TO : All Bidders  
FROM : George M. Wiens  
PROJECT : CTE Classroom Addition  
Vista Murrieta High School  
1615400.41  
SUBJECT : Addendum 2  
DSA : 04-115755 / 33-H18

Addenda No. 2 – Scope of Work Questions

DRAWING NUMBER: **AW2.2**

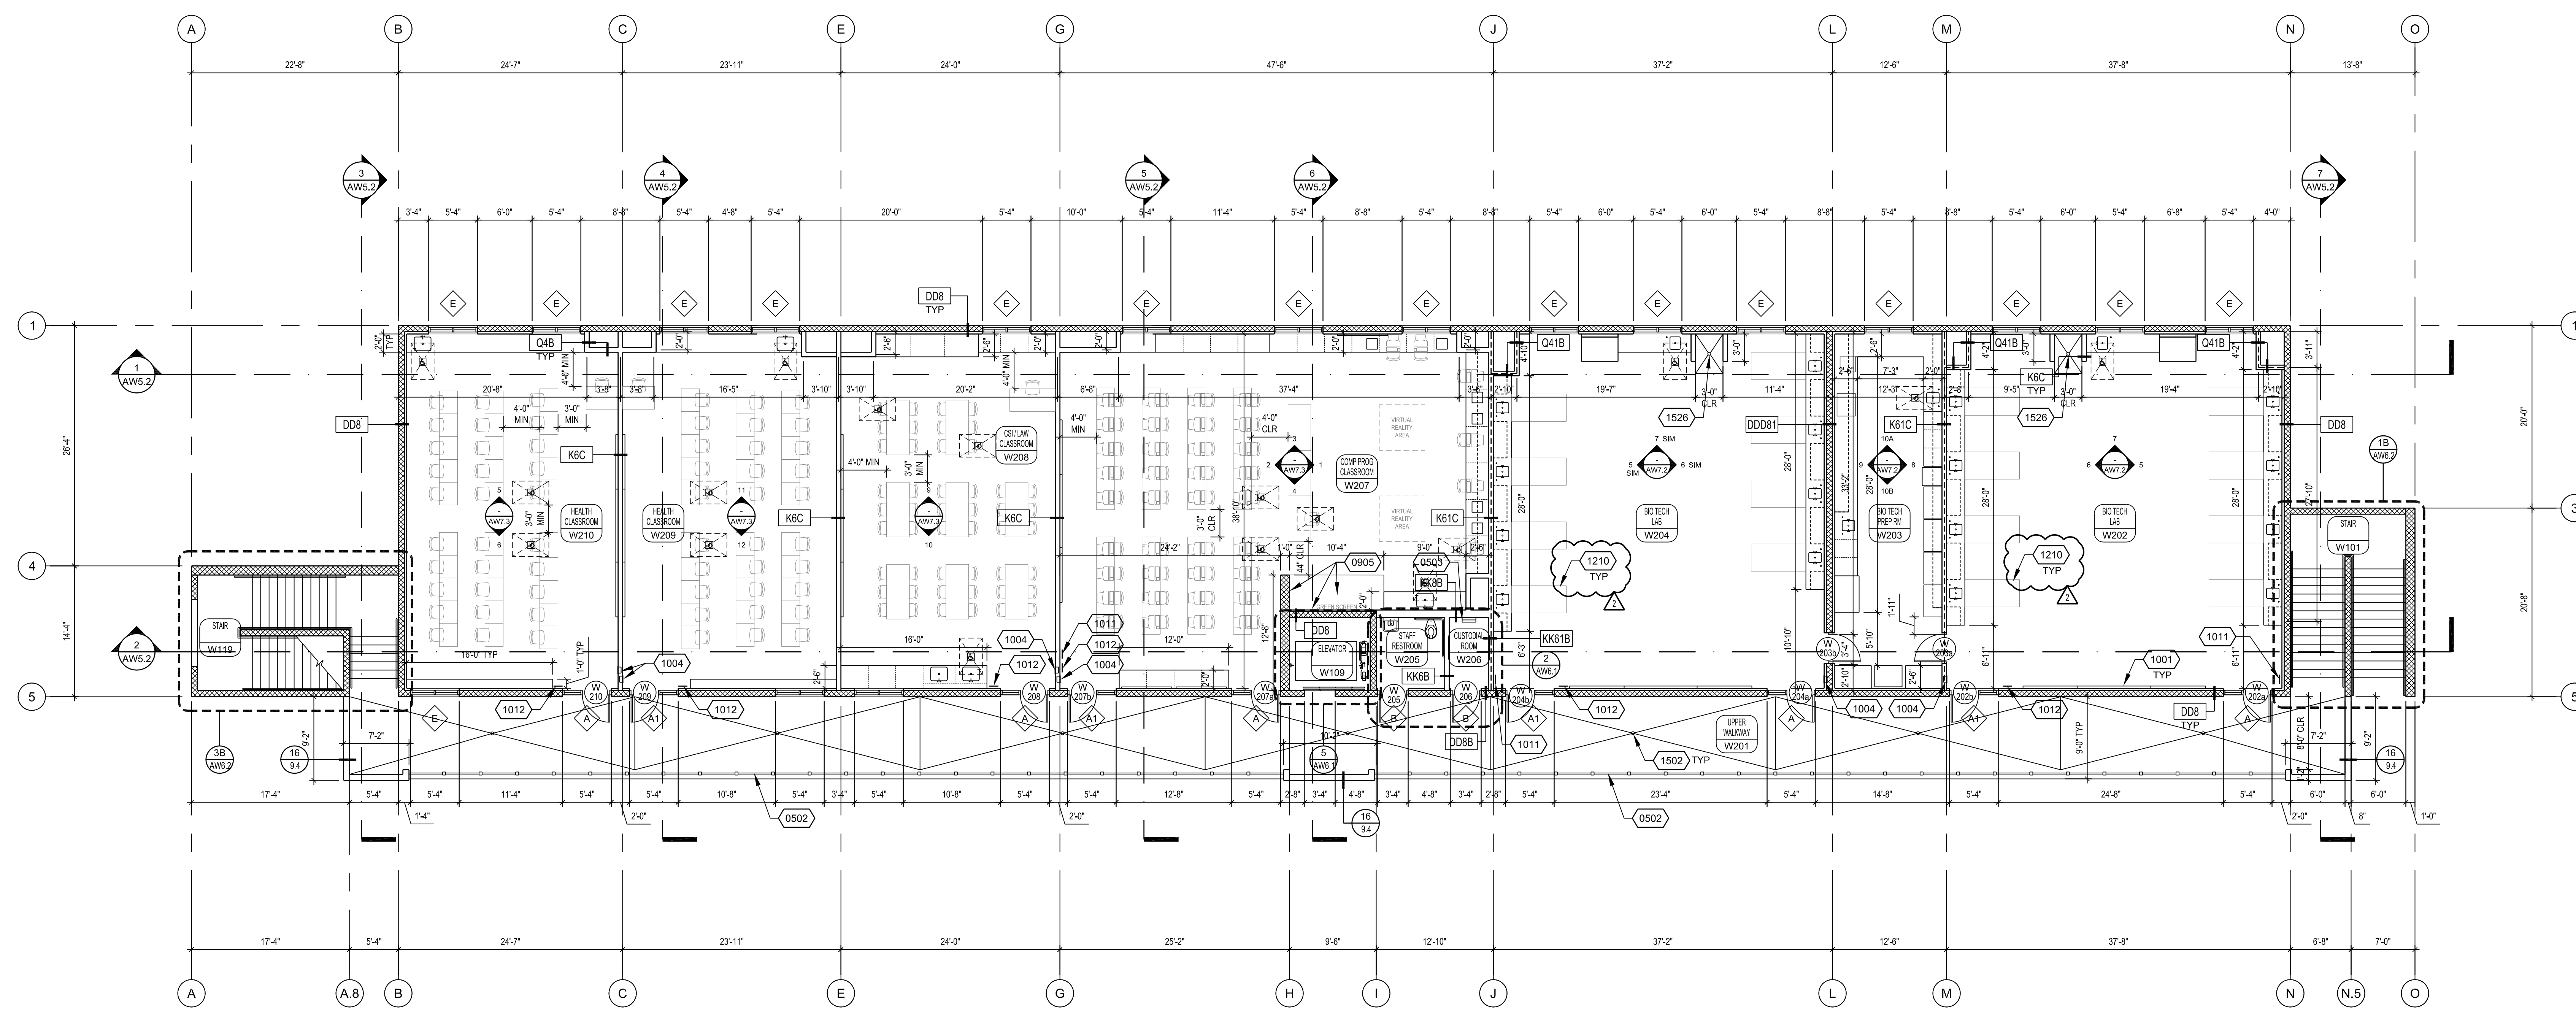
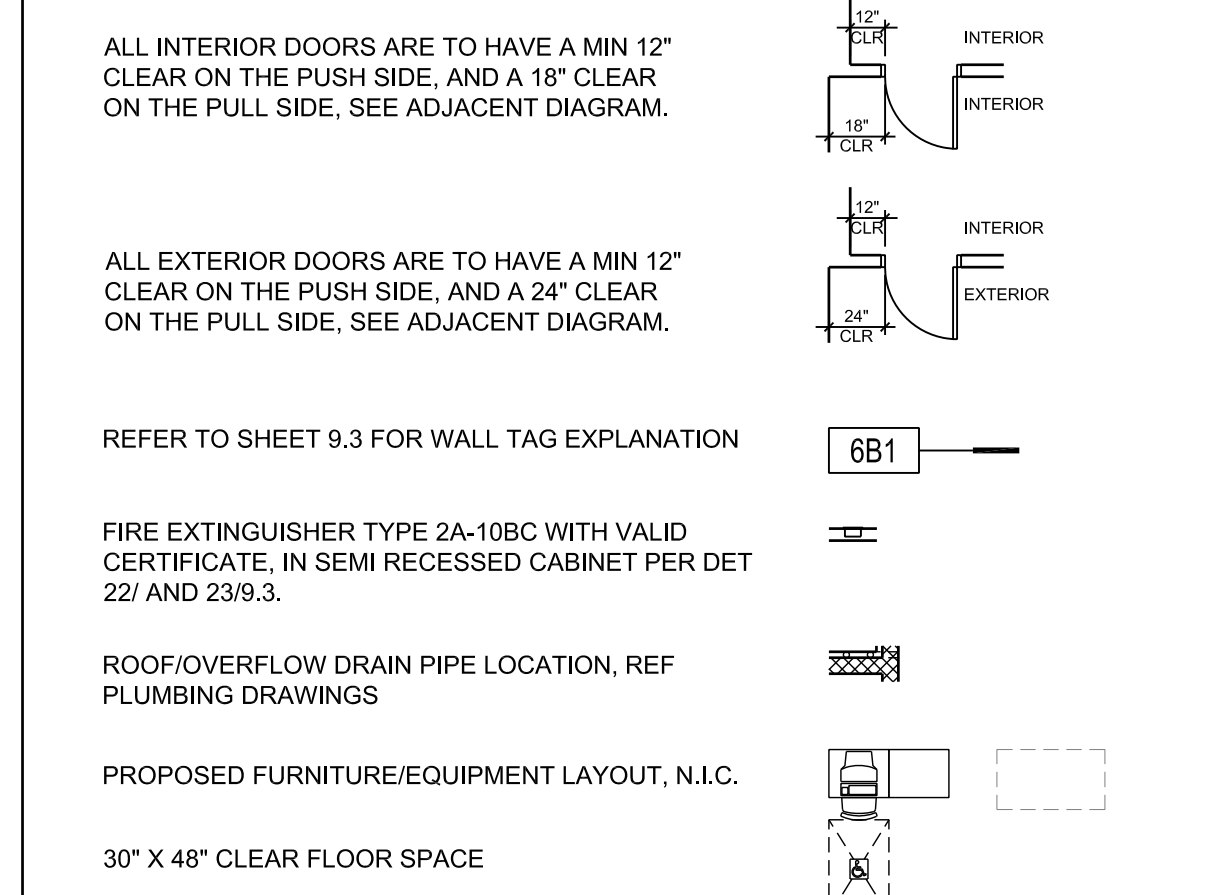
- A. Revise as indicated in the clouded area labeled Delta 2 on the attached AW2.2.
